CITY OF SAN FERNANDO
CALIFORNIA

ADDENDUM NO.1
FOR
FISCAL YEAR 2023-2024
PHASE 3, ANNUAL STREET RESURFACING PROJECT
JOB NO. 7621, PLAN NO. P-743

ADDENDUM NO.1

**San Fernando Phase 3
Street Map**

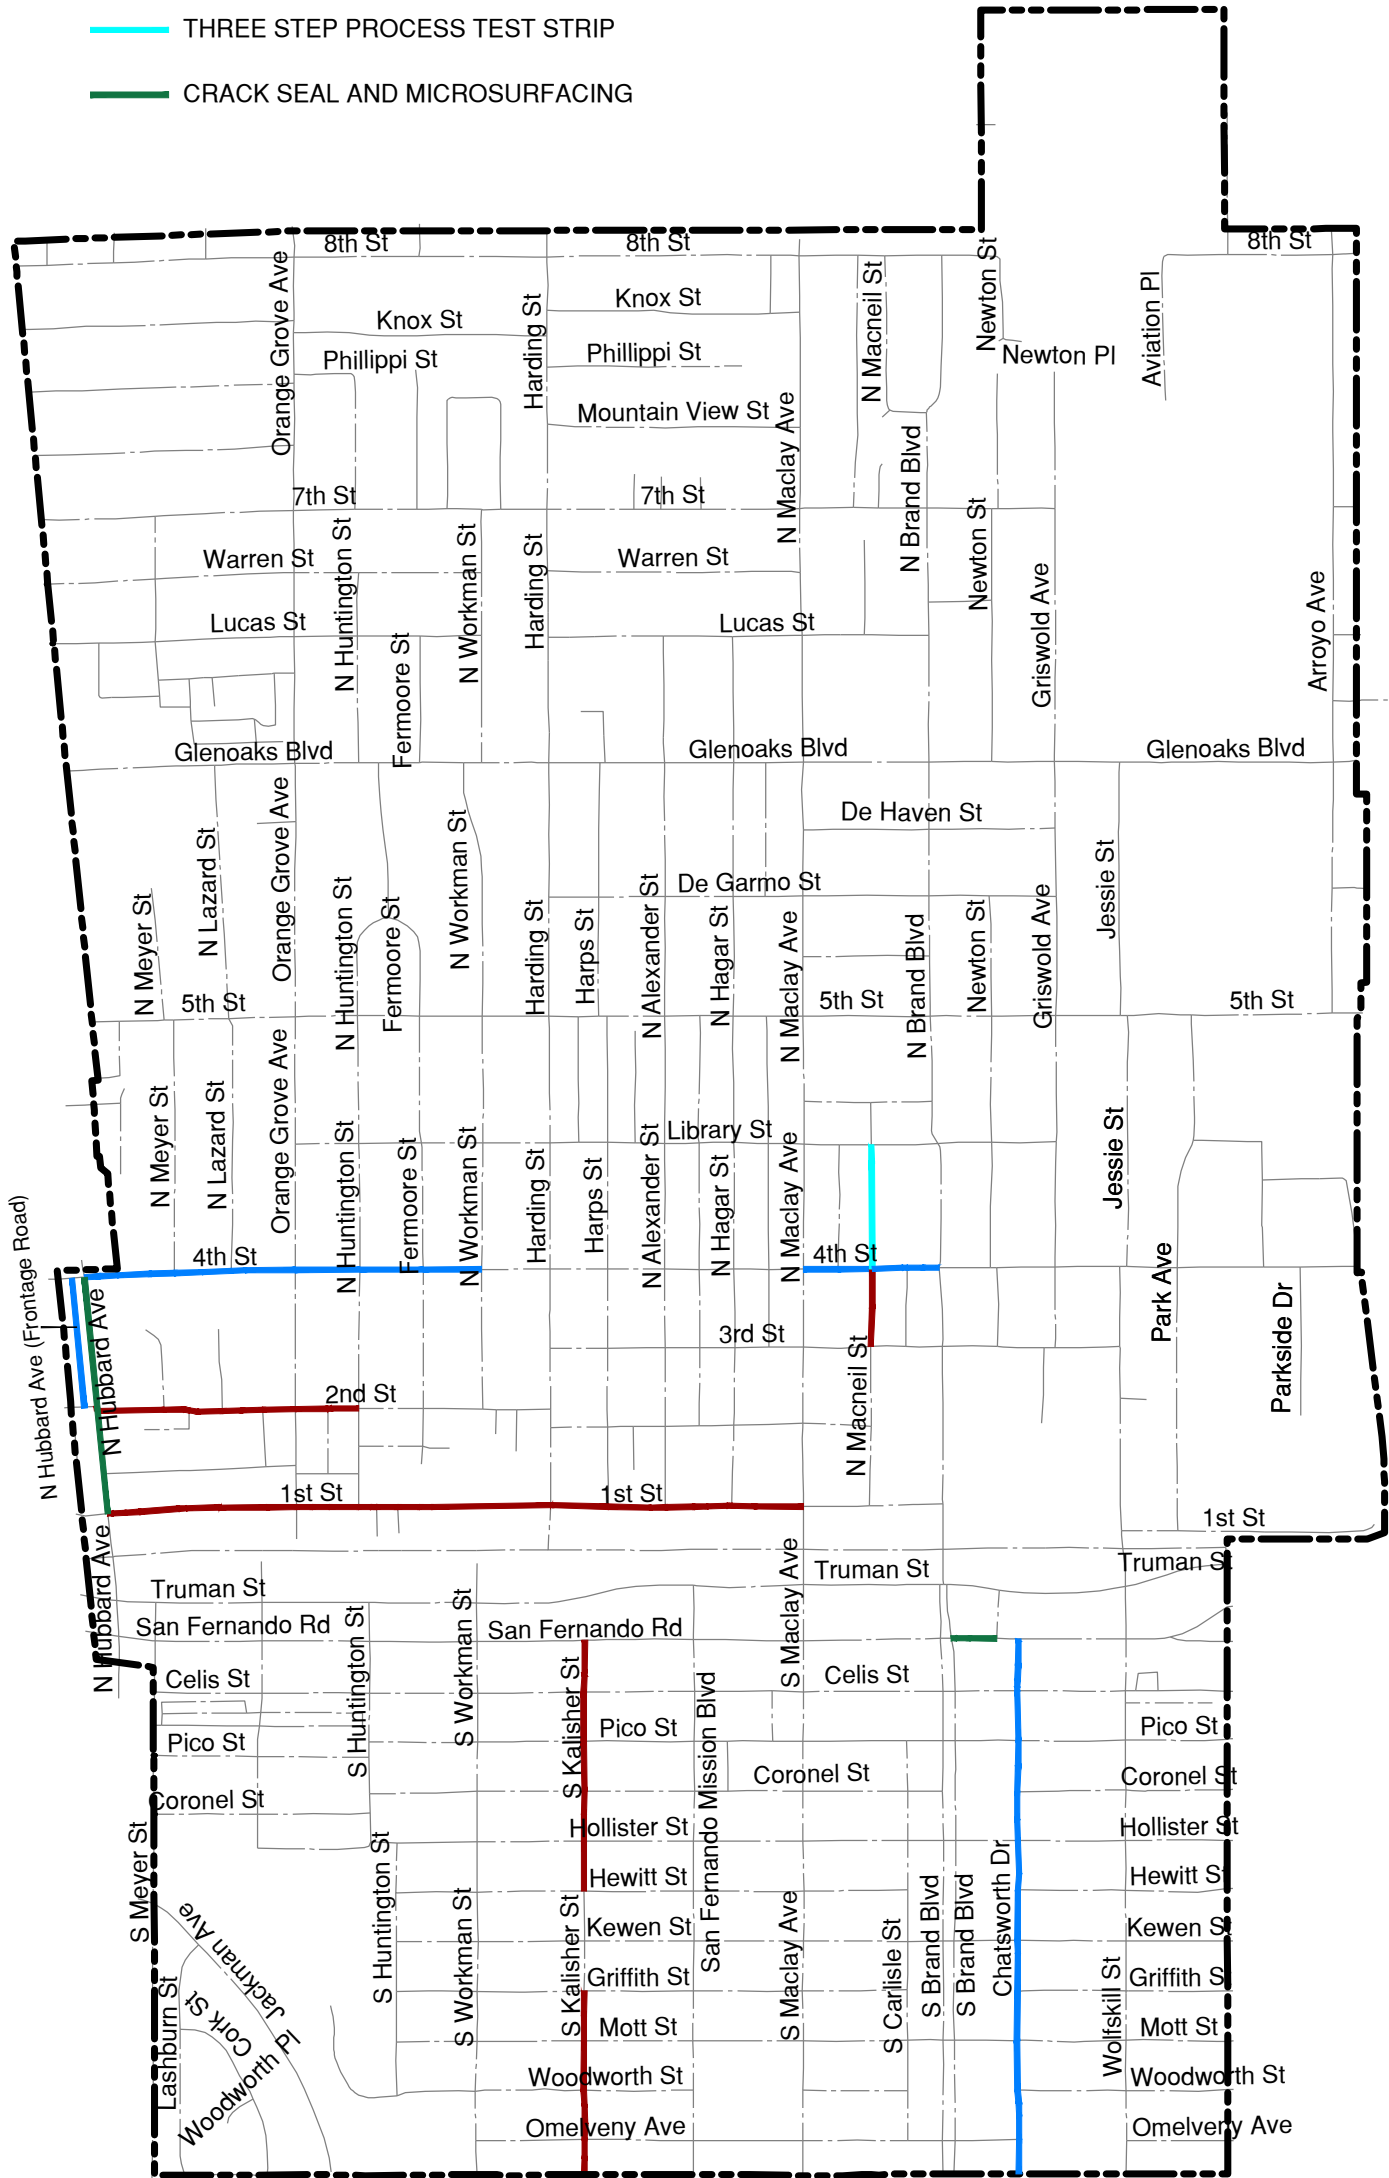
- 2) Please use the attached updated bid schedule (Attachment "A").
- 3) Hubbard Avenue from First Street to Fourth Street and San Fernando Road from Brand Boulevard to Kittridge Street has been updated to receive microsurfacing, in lieu of the 3-step process.
 - a. For these two sections, all pavement cracks **≥1/4-inch** wide shall be repaired. The following crack repair procedures shall be performed:
 - i. Remove loose particles, debris, dust, and organics from the cracks. These cracks should be brushed clean and blown with compressed hot air to remove debris, dust, and moisture. Weeds should be removed, and herbicides shall be sprayed. The cracks should be dry before applying crack fill material.
 - ii. Crack fill shall be squeegeed flush to 1/4-inch below flush.

Crack seal material shall be a hot-applied, rubberized crack-fill material, such as CRAFCO Polyflex Type 3 sealant or equal.

Cracks repairs must be performed at least **2 weeks** prior to applying microsurfacing.
